1992 Corvette: Service Bulletin: Brake Pedal Not Fully Returning / Stop Lights Stay On and/or Roughness/Vibration From Rear of Vehicle

Model and Year: 1992 CHEVROLET CORVETTE

Bulletin Number: 92-71A-5 - (01/31/1992)

Figure 1

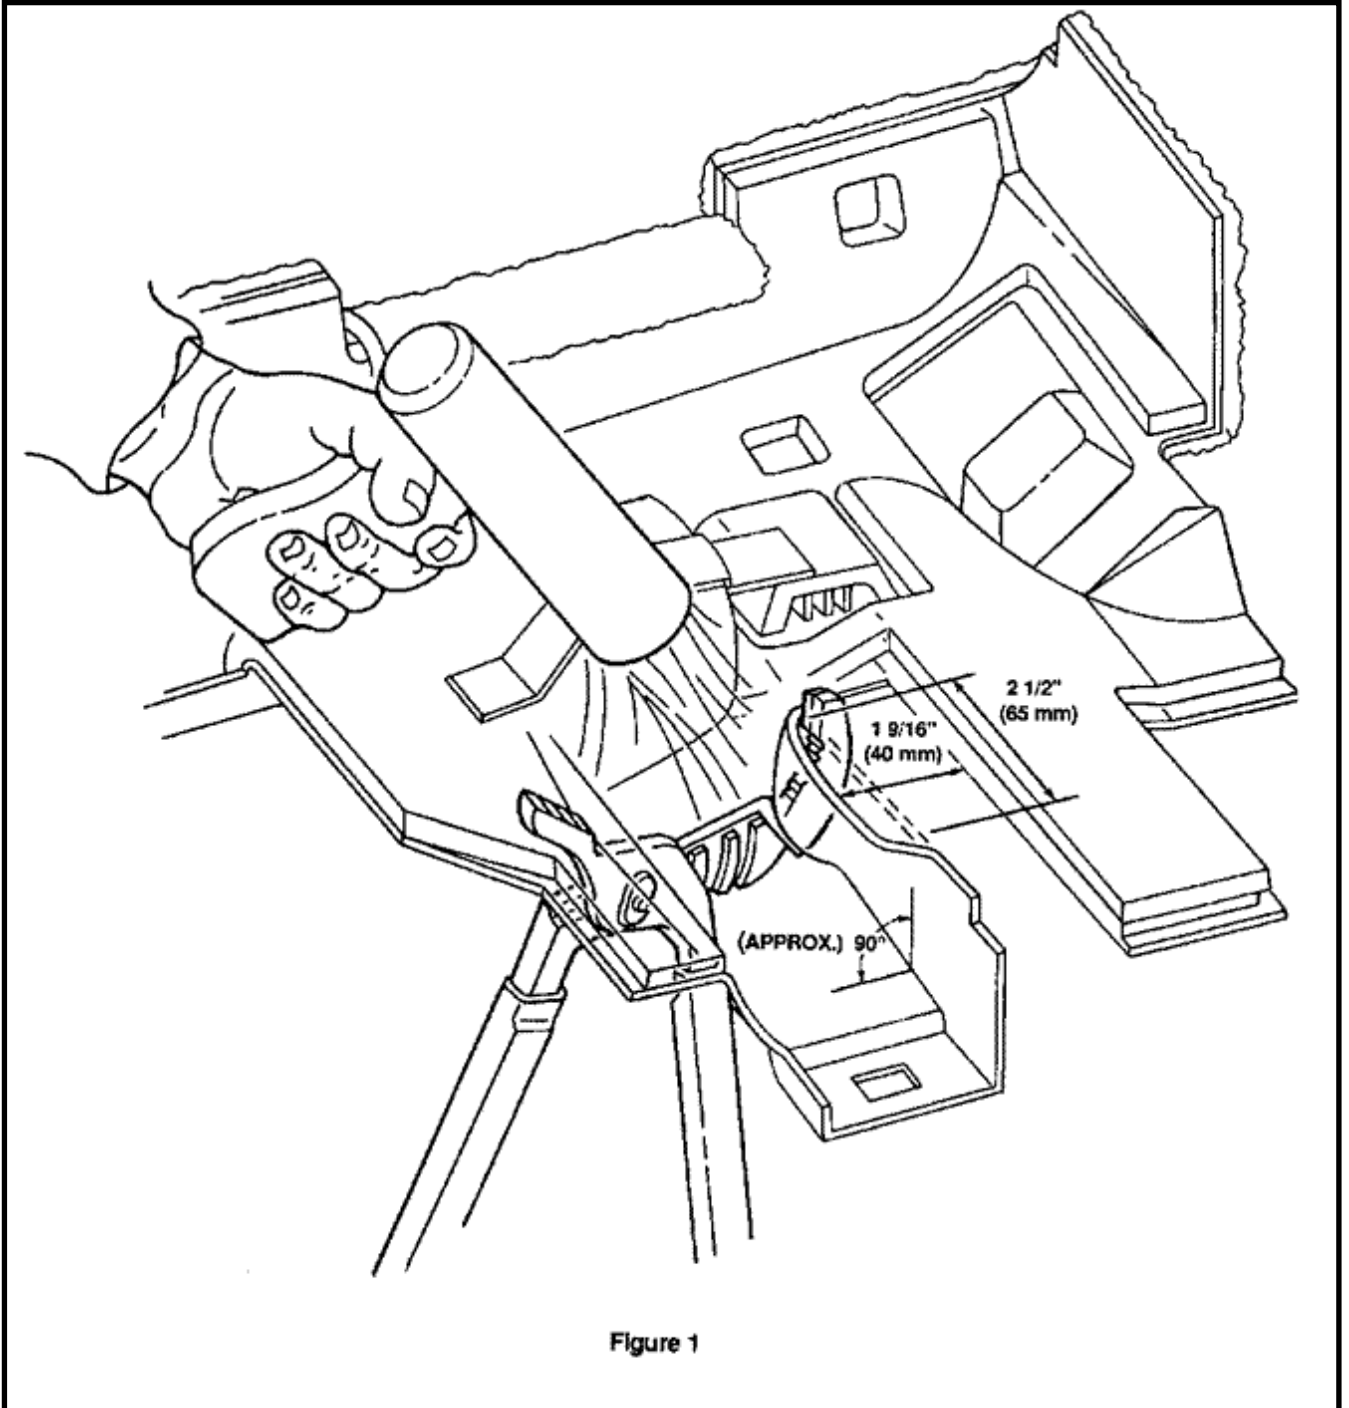
Some 1992 Y-car base Corvettes built from SOP to VIN breakpoint 104324 and ZR1's built from SOP to VIN breakpoint 800193 may exhibit inadequate clearance between the brake service pedal arm and the I/P lower trim panel.

Determine if interference exists between brake pedal arm and I/P lower trim panel (a minimum clearance of 2mm (.080 in.) is required). To verify clearance, an item approximately 2mm thick, such as a 2mm shim, should pass between the trim panel and pedal arm on both sides. If there is clearance, diagnose concern per Service Manual, Section 5-3. If the minimum clearance does not exist, perform the following steps:

1. Remove LH lower trim panel (per Service Manual, Section 8C-33).
2. Lift away the foam sound deadener from area shown in Figure #1, and tape out of the way.
3. Using a heat gun, warm the trim panel area shown in Figure #1 (USE CARE TO WARM COMPLETE AREA EVENLY).
4. Using Channel Locks (R) size 16 or larger, place near the upper LH corner of the I/P lower trim panel as shown in Figure 1. Quickly reform the brake pedal opening to configuration and dimensions indicated in illustration. If necessary Channel Locks may be moved downward during initial reforming and/or Steps 3 and 4 may be repeated to obtain minimum clearance of 2mm between the brake service pedal arm and the I/P trim panel.

5. Reinstall lower trim panel. Remeasure the clearance between trim panel and the brake pedal arm, using method stated in correction above.
6. If contact still exists, phone Action Center #1 -800-457-8388.
